**ADDENDUM
NO. 4**

October 18, 2024

**Whiteland High School Ph 2: Café Kitchen Band Choir Auditorium
300 E. Main Street
Whiteland, IN 46184**

FLOOR PLAN - FIRST FLOOR - UNIT P.2

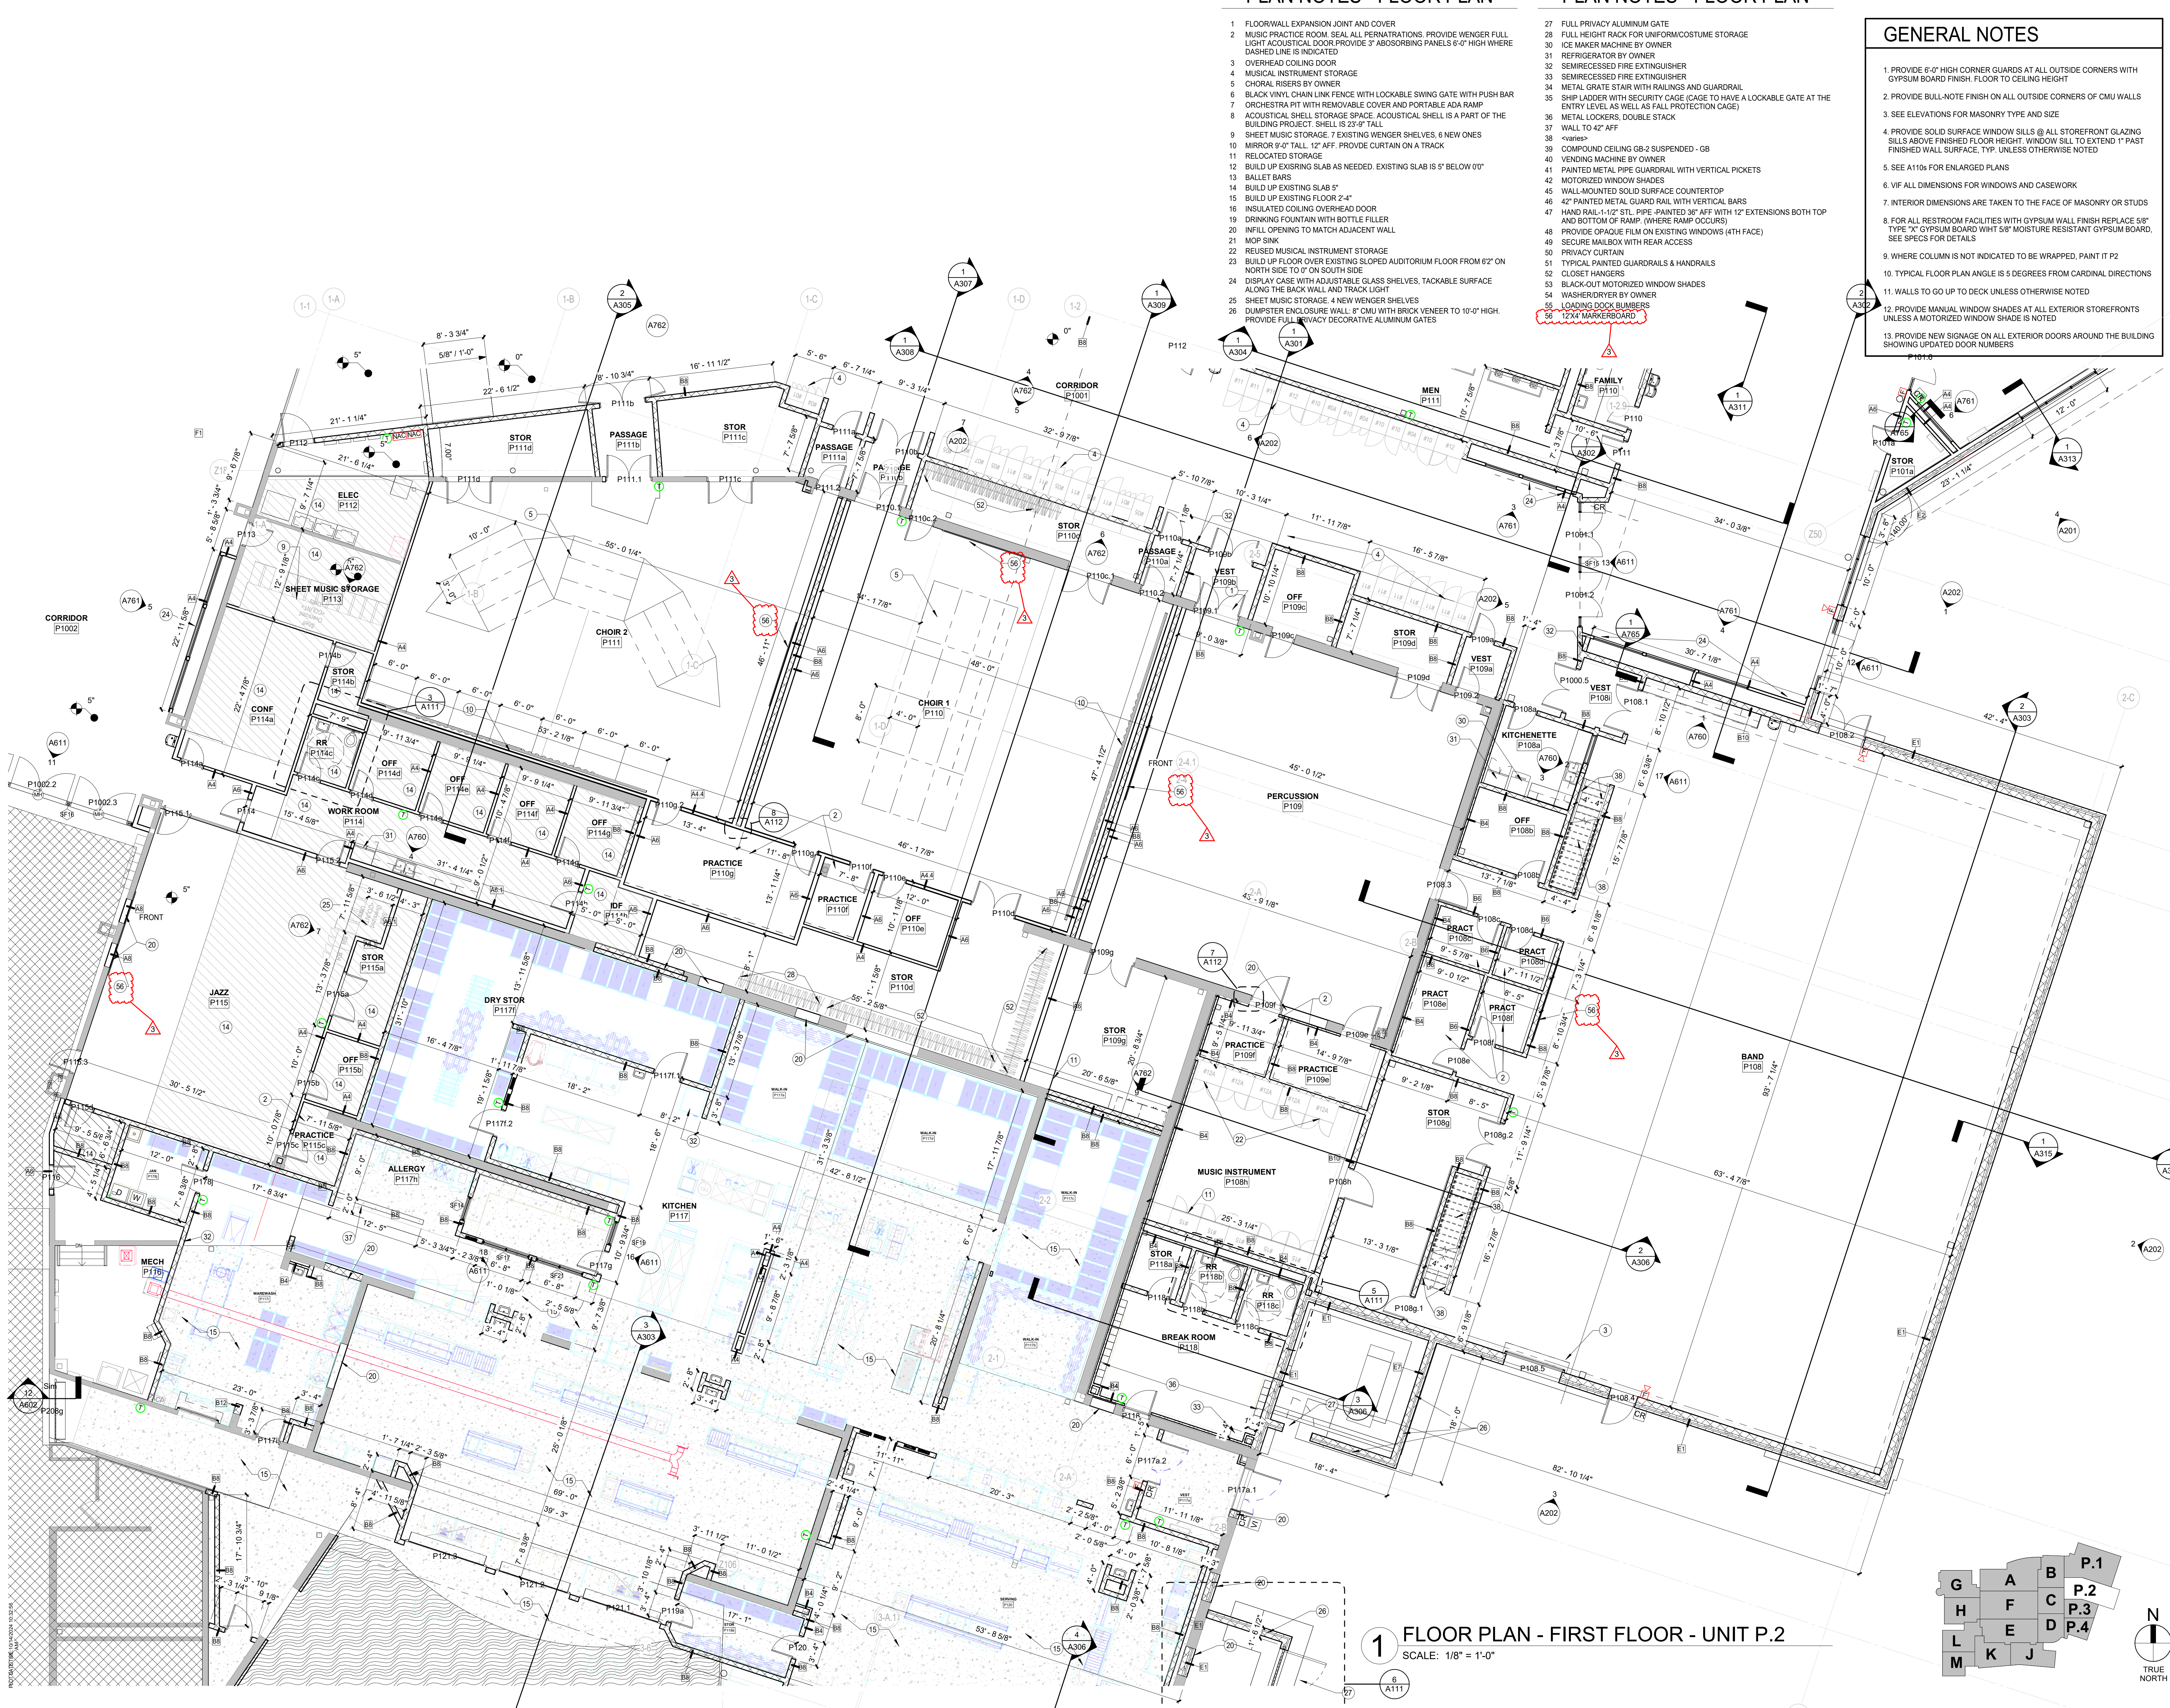
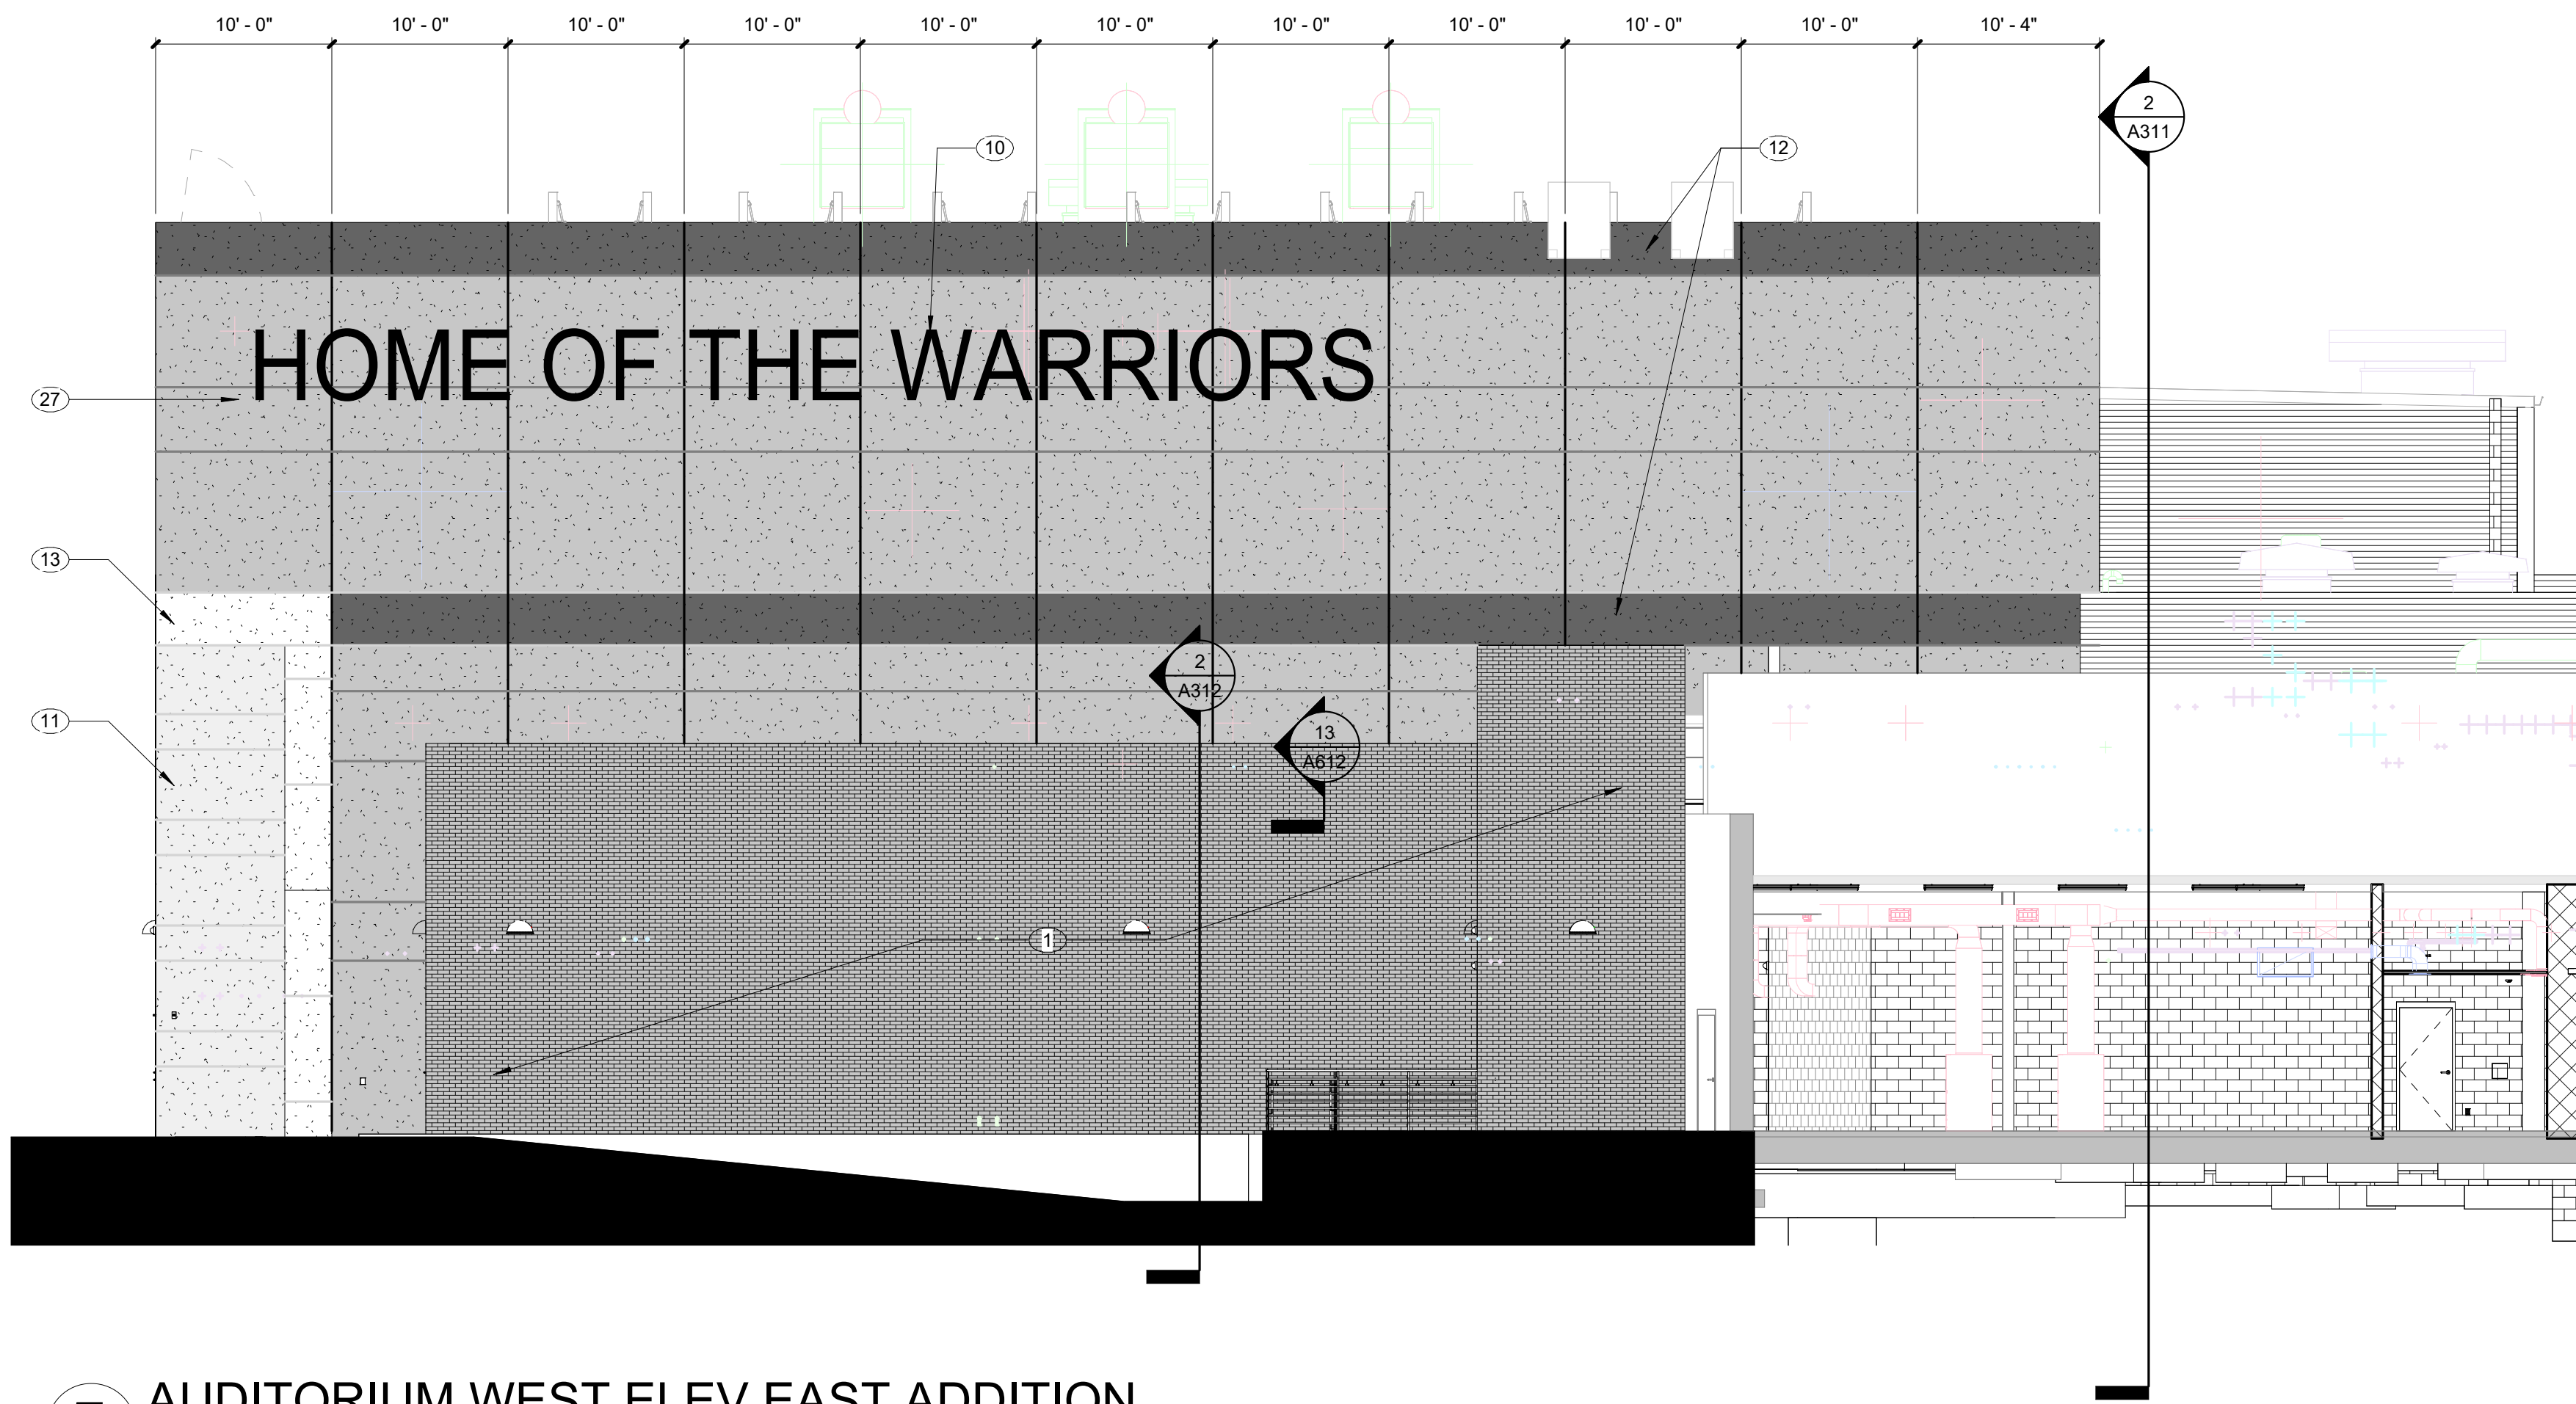
5. SHEET NUMBER: A101P.2
SHEET TITLE: FLOOR PLAN -FIRST FLOOR – UNIT P.2

Add keynote 56 "12'x4' MARKERBOARD"
Added notes to the Band room, Percussion room, Choir rooms, and Jazz

WINDOW SCHEDULE

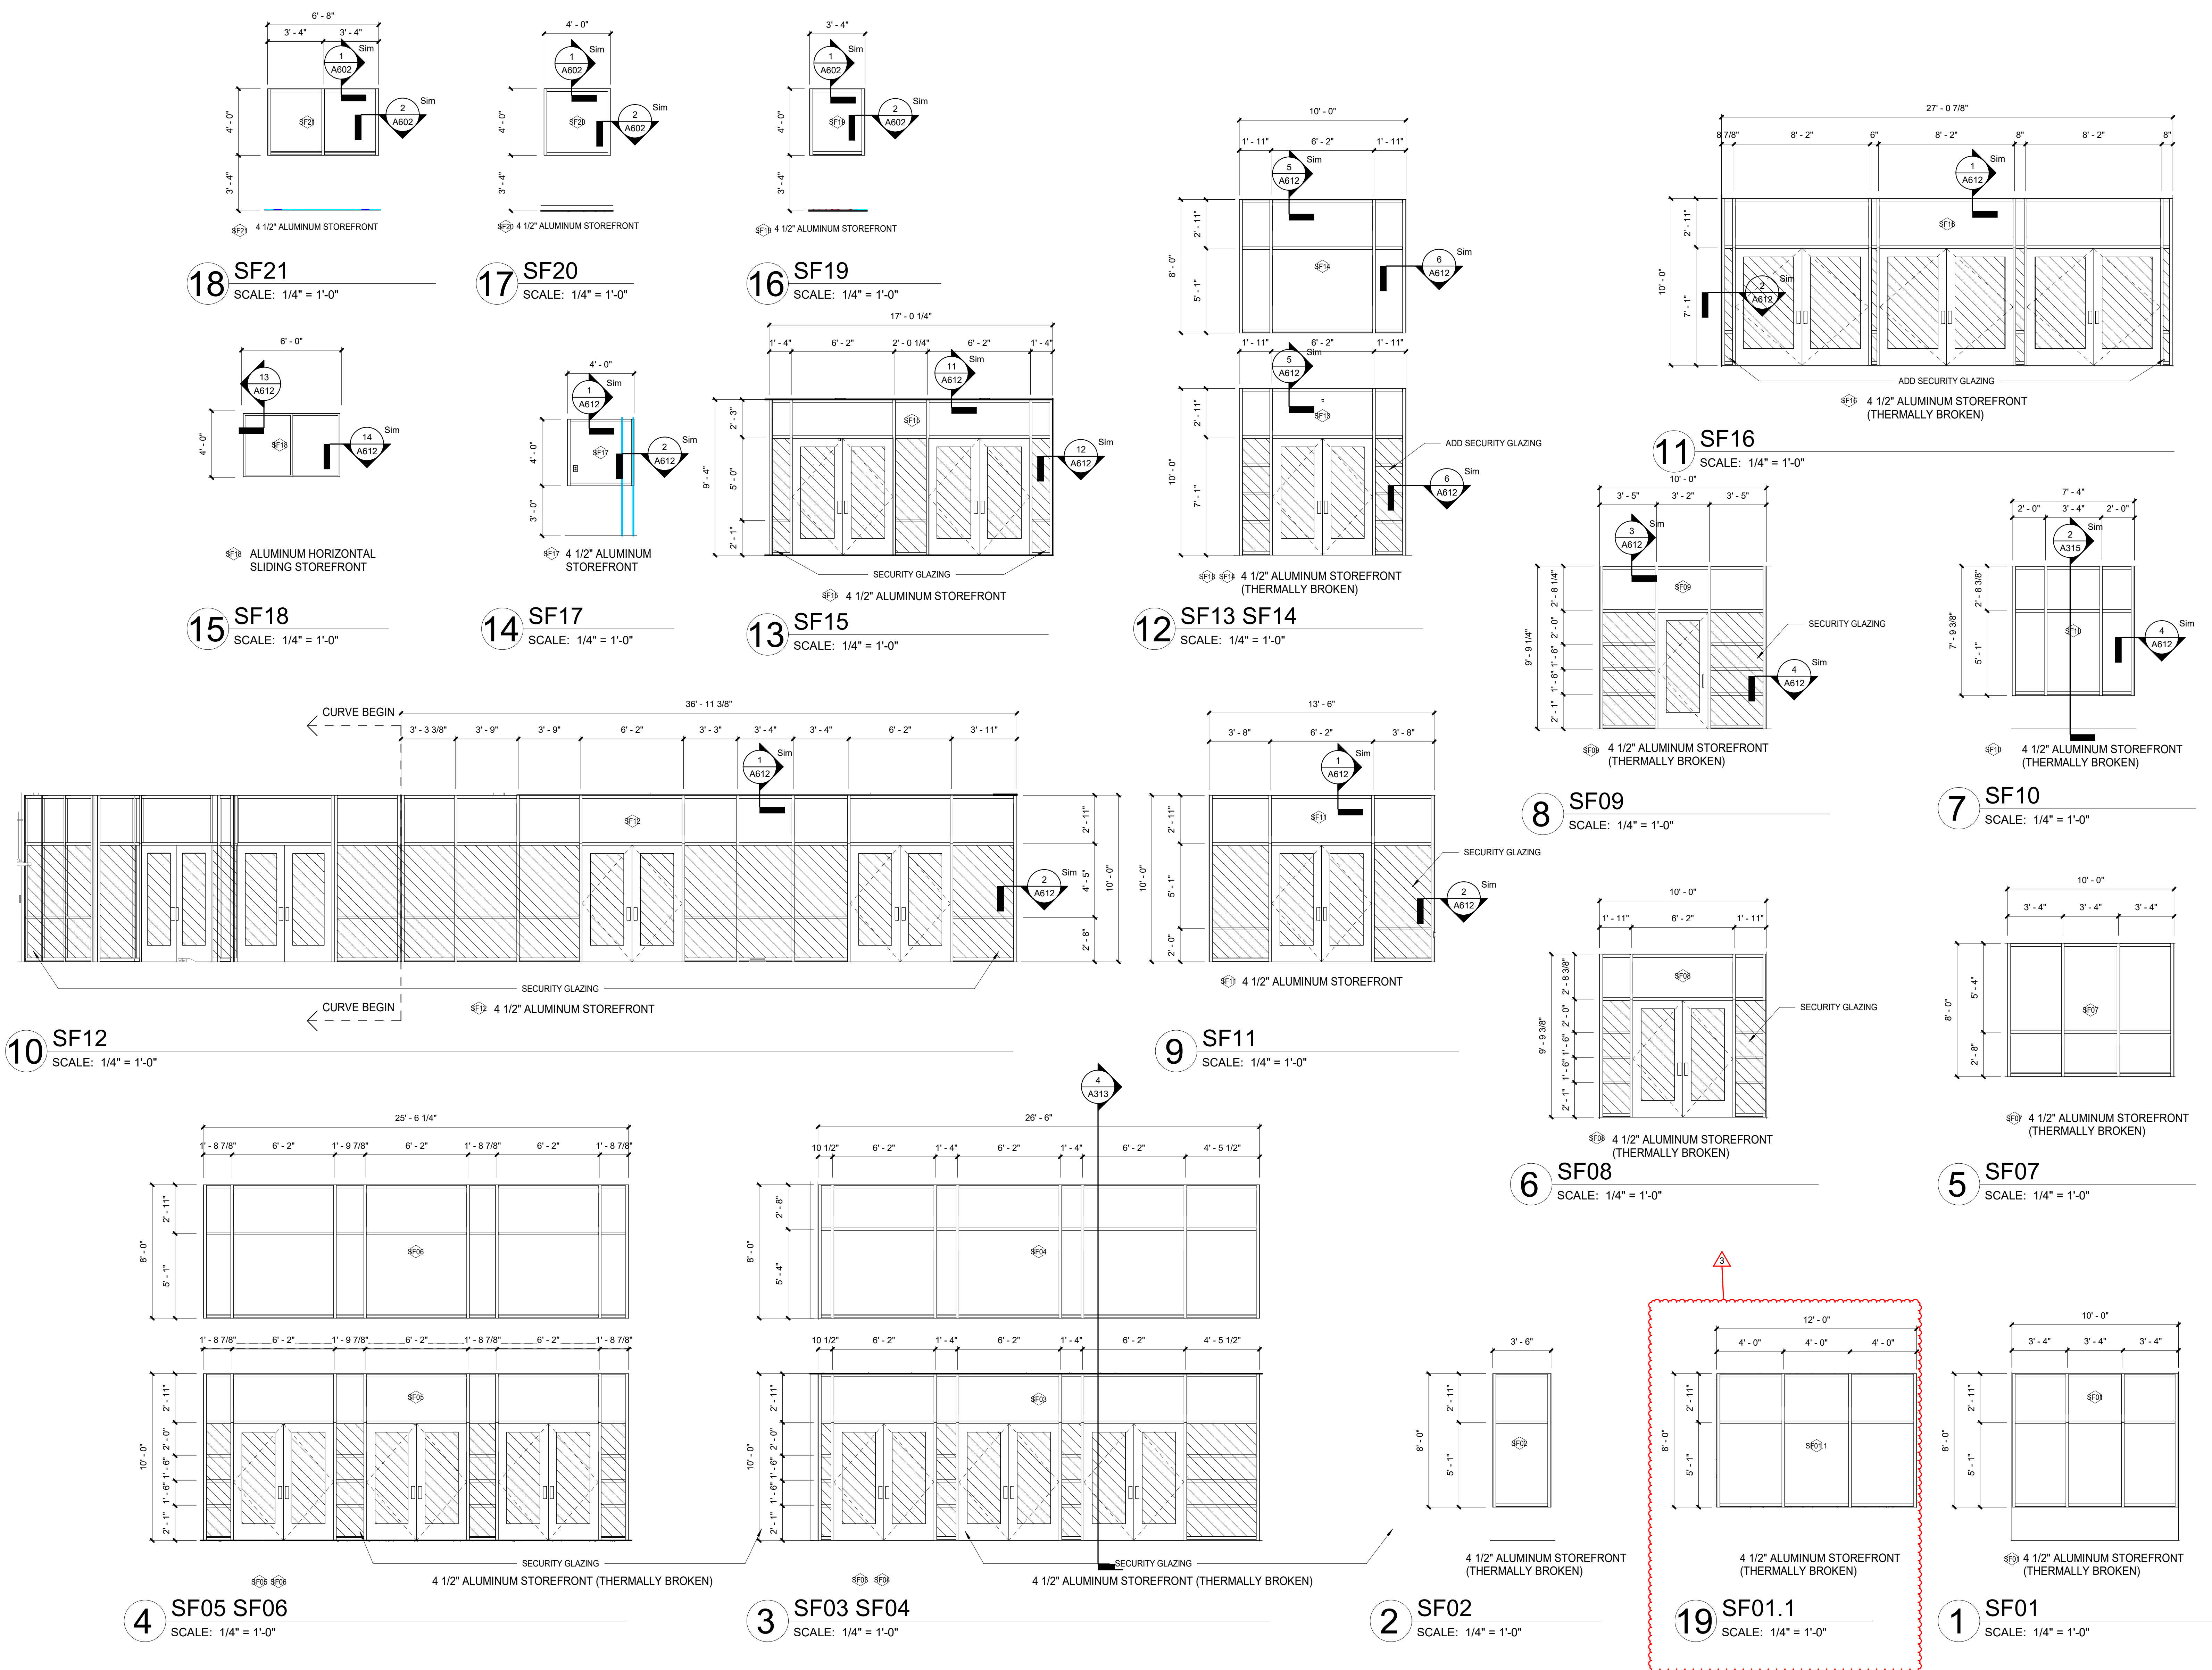
8. SHEET NUMBER: A611
SHEET TITLE: WINDOW SCHEDULE

Add detail 19 to show elevation SF01.1
